1 Q. CA/KPL-Nalcor-003 indicated only minor increase in installed capacity within the
2 existing hydropower generation pool are possible. Please share the minor options.
3 Has pumped storage been investigated?
4

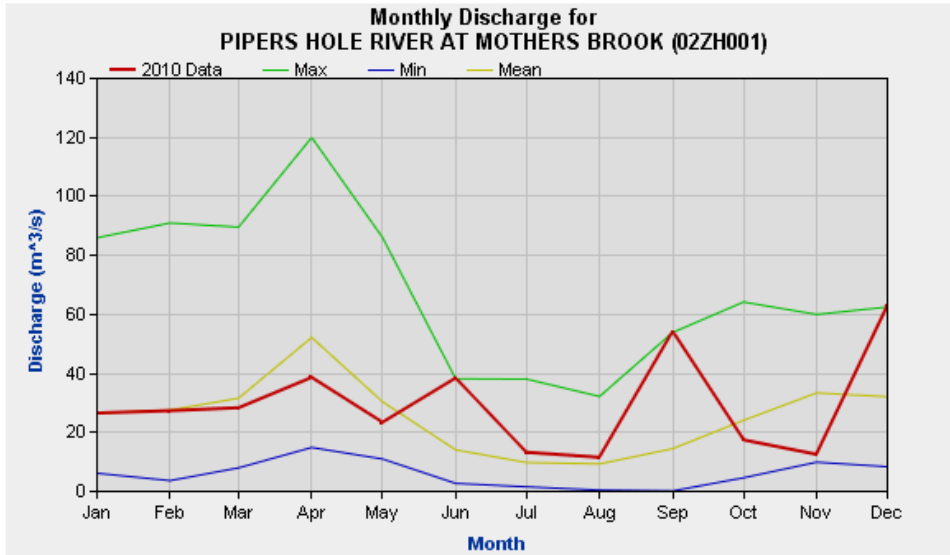
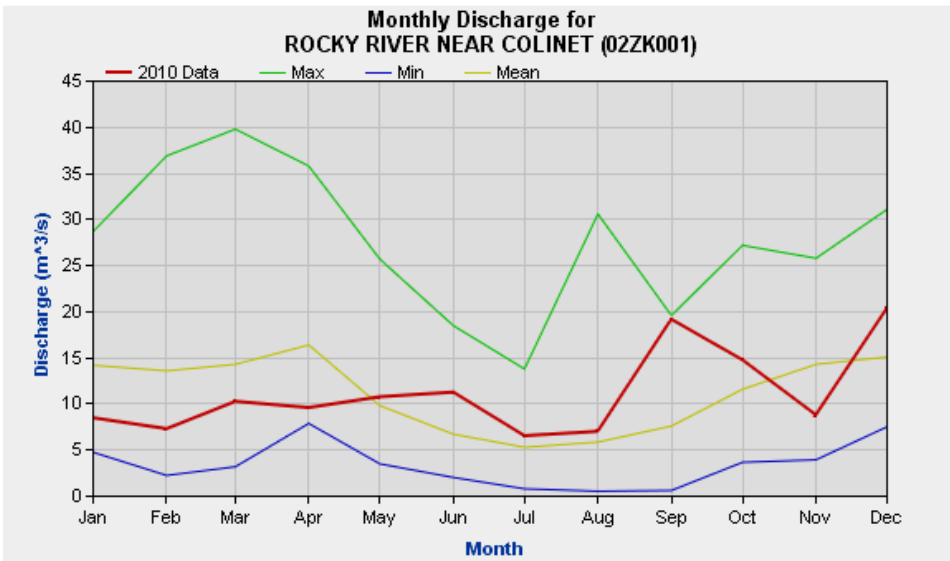
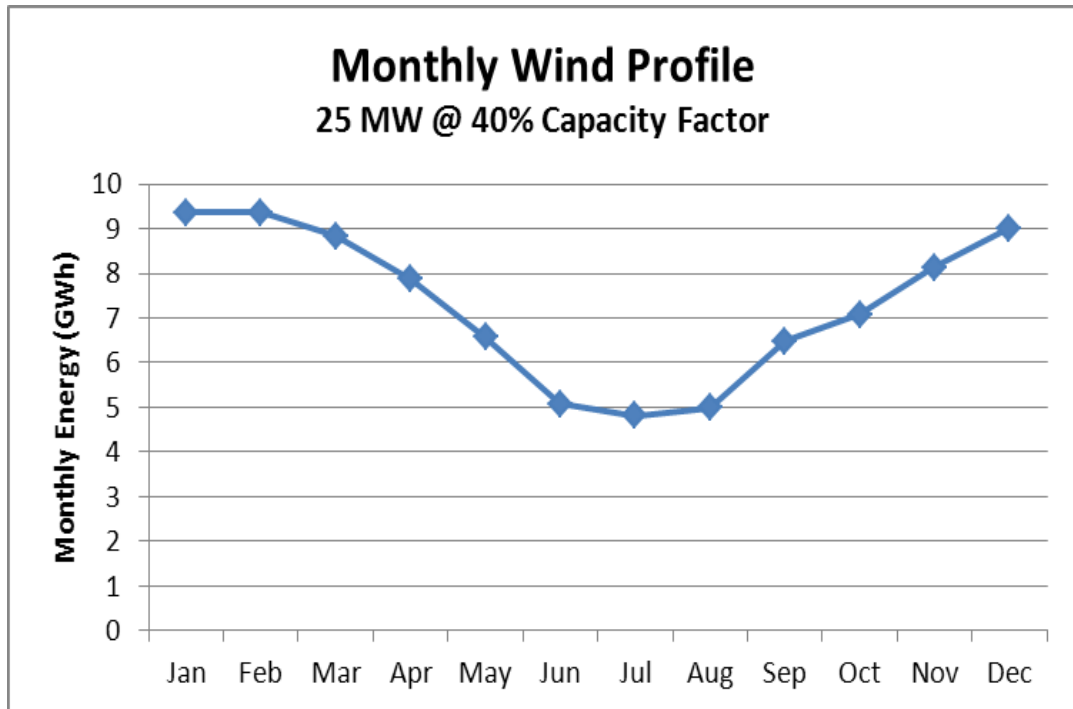
- 1 Q. Please show the typical anticipated monthly generation profile from run-of-river
 2 and wind power sources in Newfoundland.
 3
 4 A. Following are discharge profiles for four different areas of Newfoundland:

1 Following is an an expected monthly generation profile for a 25 MW wind farm with
2 a 40% annual capacity factor. Please refer to Nalcor’s response to MHI-Nalcor-87
3 for the rationale for using a 40% capacity factor.
